PCN# 20121113000

Correct Excessive VBACKUP Current Draw and
Isolate VSS_OSC from PCB Ground on

MityARM-335X Family System on Modules

PCN Number: 20121113000
PCN Date: November 13, 2012
Title: Correct Excessive VBACKUP Current Draw and Isolate VSS_OSC from PCB Ground
Contact: Bill Halpin
Phone: (315) 425-4045
Ship Date: 03/01/2013

Figure 2 MityARM-335X PMIC / Processor Interconnector, with change applied

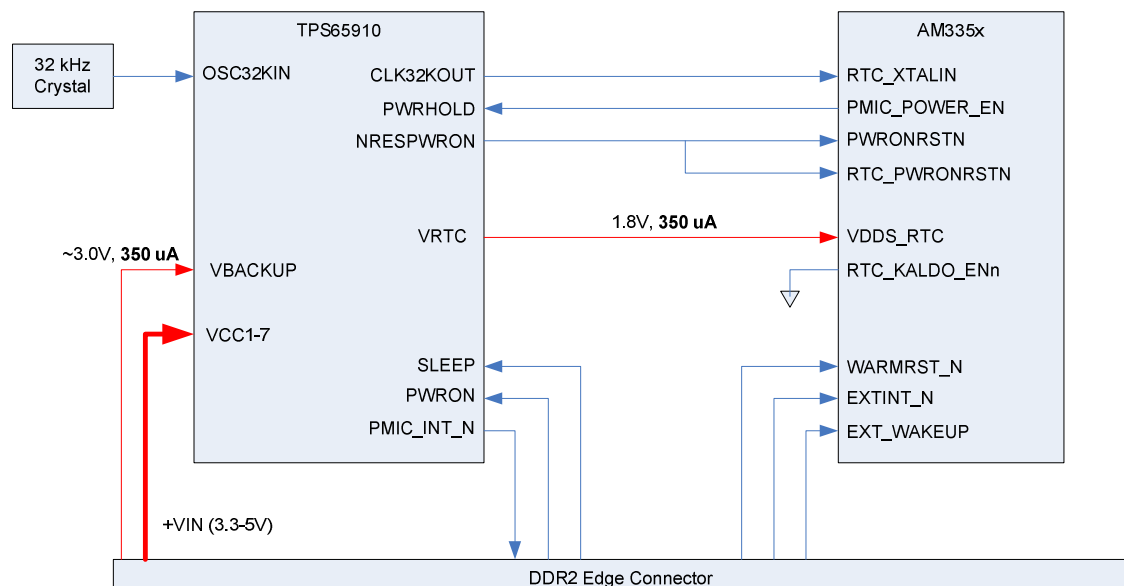
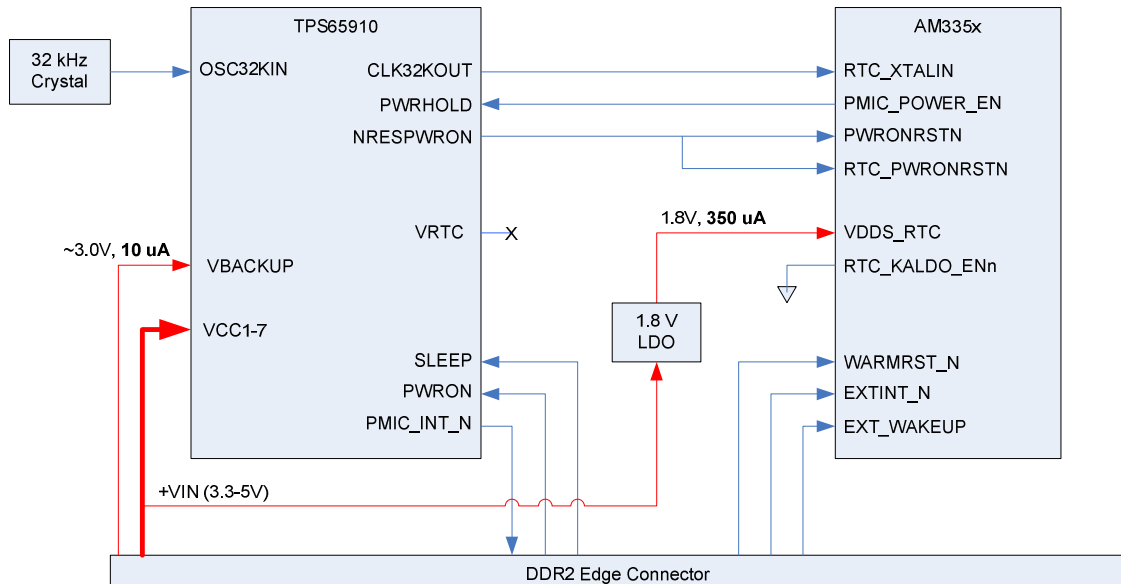
The AM3359 VDDS_RTC 1.8 Volt power input, currently supplied by the TPS65910A Power Management Integrated Circuit (PMIC) VRTC output, will be instead fed by an independent 1.8 Volt Low Drop Out (LDO) regulator sourced from the main input supply voltage.

Figure 1 illustrates the PMIC / AM3359 logical connections before the change. The TPS65910A includes a 1.8 Volt output, VRTC, that is powered by either the VCC7 input (the main power input) or the VBACKUP input if VCC7 is not present.

Figure 2 illustrates the PMIC / AM3359 logical connections with the change applied. Here, the AM3359 VDDS_RTC has been disconnected from the PMIC's

VRTC output. Instead a separate LDO regulator is used to supply the 1.8 Volts needed to power the VDDS_RTC input.

The intent of the VBACKUP power input on the MityARM-335X family of SOMs is to provide the capability for the application developers to use the available on-board RTC features of the PMIC using an inexpensive coin-cell type battery while main power is not available. Without this change the current/power consumption on the VBACKUP input – 350 micro Amps - is simply too high to facilitate this feature. The change drops the input current to approximately 10 micro Amps by only powering the RTC on the PMIC. This current consumption level is reasonably low enough for typical low cost coin cell batteries.

With this change, the current consumption of the VBACKUP pin will be reduced from approximately 350 micro Amps to approximately 10 micro Amps.

Figure 4 MityARM-335X Main Oscillator Connection, with change applied

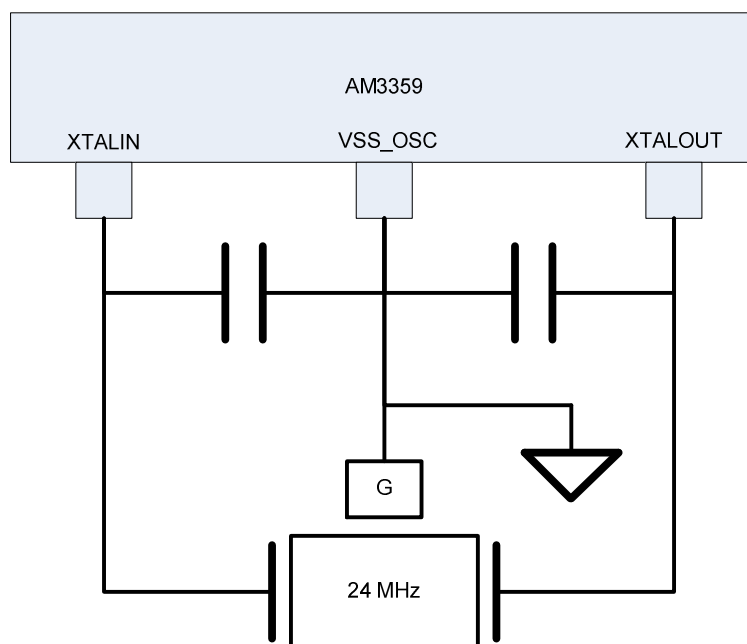
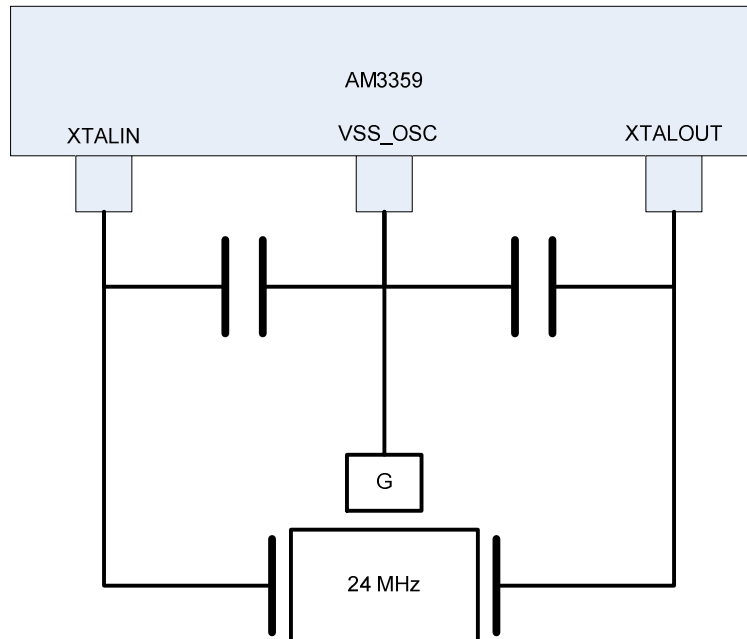
The Kelvin ground reference (VSS_OSC) terminal on the AM3359 ZCZ package is currently connected to PCB ground. This terminal and the connections associated with it will be isolated from PCB ground.

Figure 3 illustrates the AM3359 24 MHz crystal connection, including the VSS_OSC pin on the MityARM-3359.

Figure 4 illustrates the same circuitry with the change applied. The only difference is that the VSS_OSC pin and its associated connections are disconnected from PCB ground.

The processor manufacturer provides design guidance (section 4.2.2.1, Figure 4-8, Note A of the AM3359 Specification, Revised MAY 2012) that indicates that the VSS_OSC terminal should not be connected to PCB ground as it serves as a Kelvin ground reference for the external crystal components. This change is required to remain consistent with the guidelines of the processor manufacturer.

This change should improve the design margin on any clock jitter or AM3359 internal phase lock loop (PLL) stability performance. However, Critical Link has not observed or had any reports regarding problems with the AM3359 PLL and/or clock performance. Therefore it is not possible to quantify any improvement on the quality or reliability of the module.
